Performance Minerals LLC

April 8, 2024

Bentonite Performance Minerals, LLC (BPM) is submitting the enclosed a revised Large Scale Mining/Milling Permit Application and supporting information in accordance 45-6B-5 with for the Security bentonite project located west of Belle Fourche, South Dakota. The submission is complete with responses to your comments.

The enclosed booklet contains the response to comments, pages to be replaced and instructions on how to augment the copy of the permit you have in your possession.

Geological Cross Section Summary

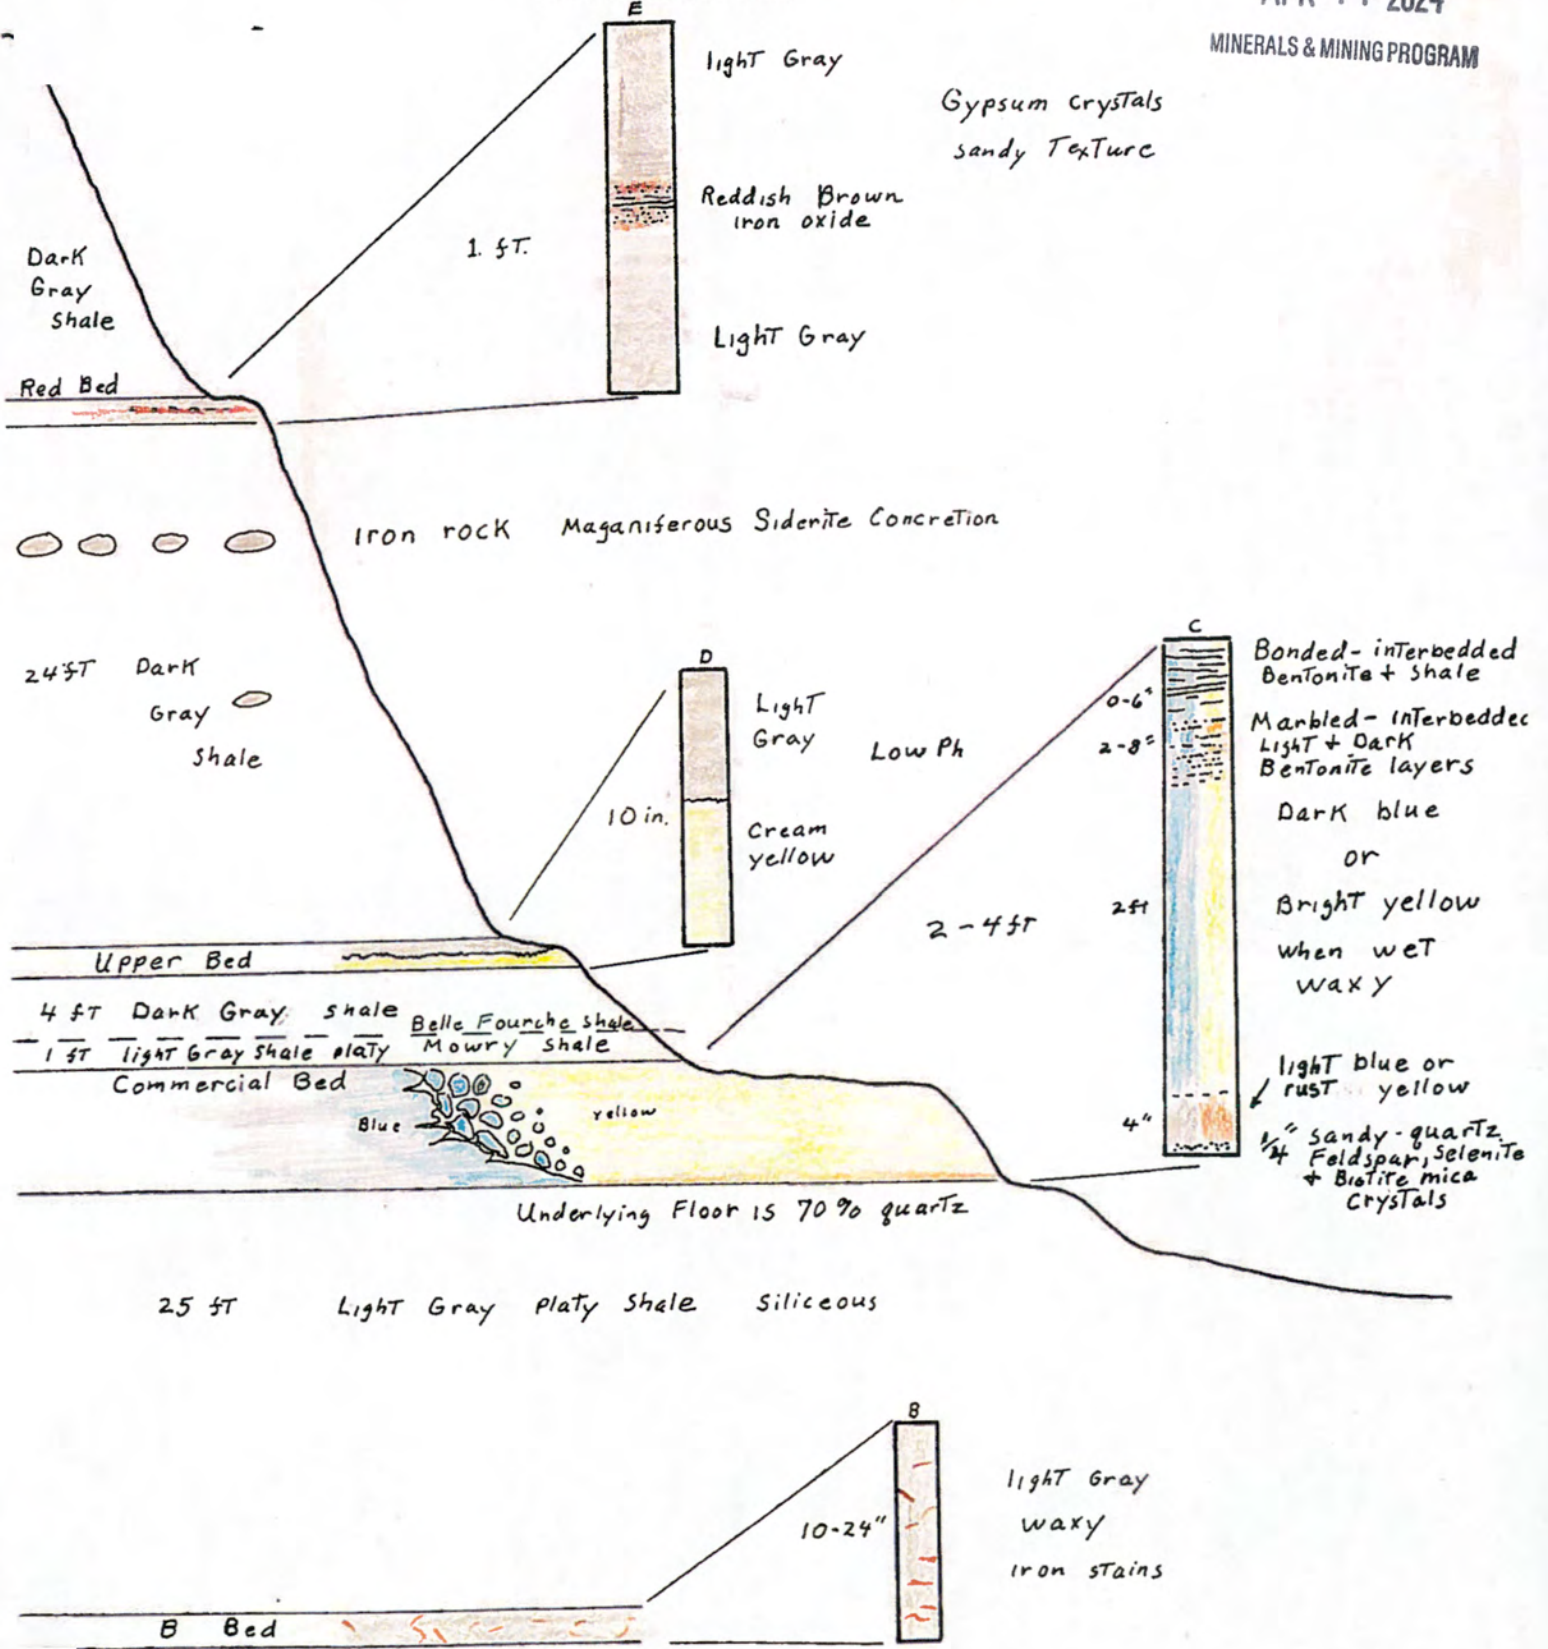
Finally, the geologic cross section on page 170 of the application is more a generic cross section rather than a representative one. This cross section would not apply to all bentonite operations since some may mine the Pierre Shale in addition to the Belle Fourche Shale. Also, depths and thicknesses of the units depicted in the cross-section may vary depending on location of the mining area. Therefore, please include a narrative with the cross section which describes the geology of the Security Mine area, the thickness of the Belle Fourche Shale, the general trend of the formations, whether the bentonite bed is found shallower or deeper in areas due to formation thickness, and which portions of the proposed mine area has shallower and deeper bentonite beds.

I have created a Geologic Cross Section Summary on page 171A that discusses the local and regional geology. I have also relabeled the cross section on page 170 to clarify it being specific to the Commercial bed. Through this process I also noted that the cross-section B-B' was incorrectly labeled, I have corrected this by switching the B and B' on page 227.

Operating Plan Map

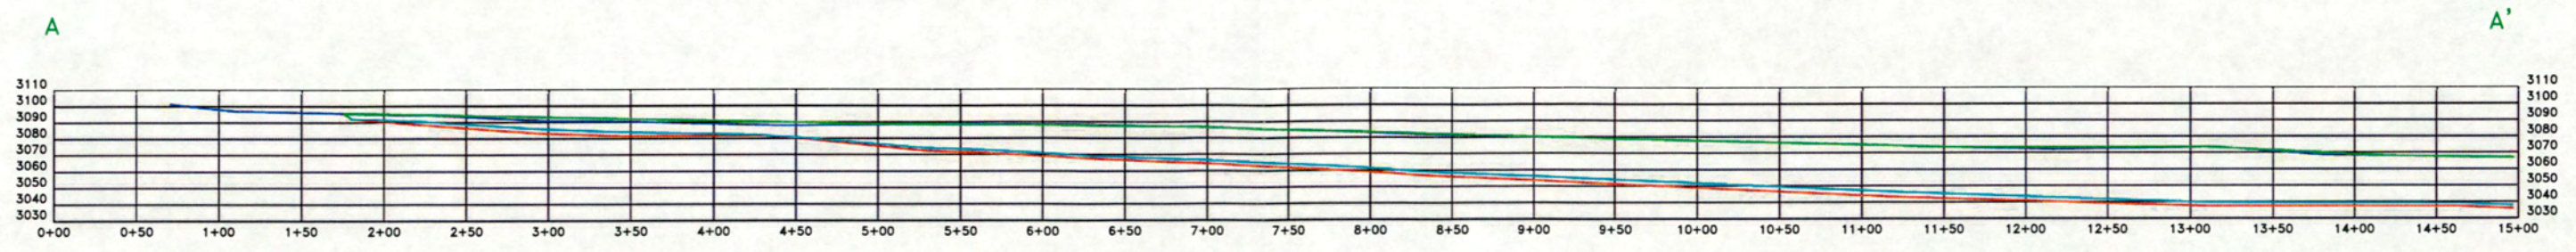
2. SDCL 45-6B-10(3), ARSD 74:29:01:17, ARSD 74:29:02:09, ARSD 74:29:02:11(2) and ARSD 74:29:02:12(7): Regarding the Operating Plan Map, the proposed mine permit boundary is not included in the map legend. Please submit a new map with the permit boundary included in the map legend. Also, there is no map scale on the two Surface Hydrology and Feature maps. Please submit new maps with a map scale. In addition, the Surface and Mineral Ownership map does not have a title and the "American Colloid" name under "Surface Ownership" in the map legend has something else typed over it and is hard to read. Please submit a new map with a title and the typo in the legend corrected.

The referenced maps have been adjusted.
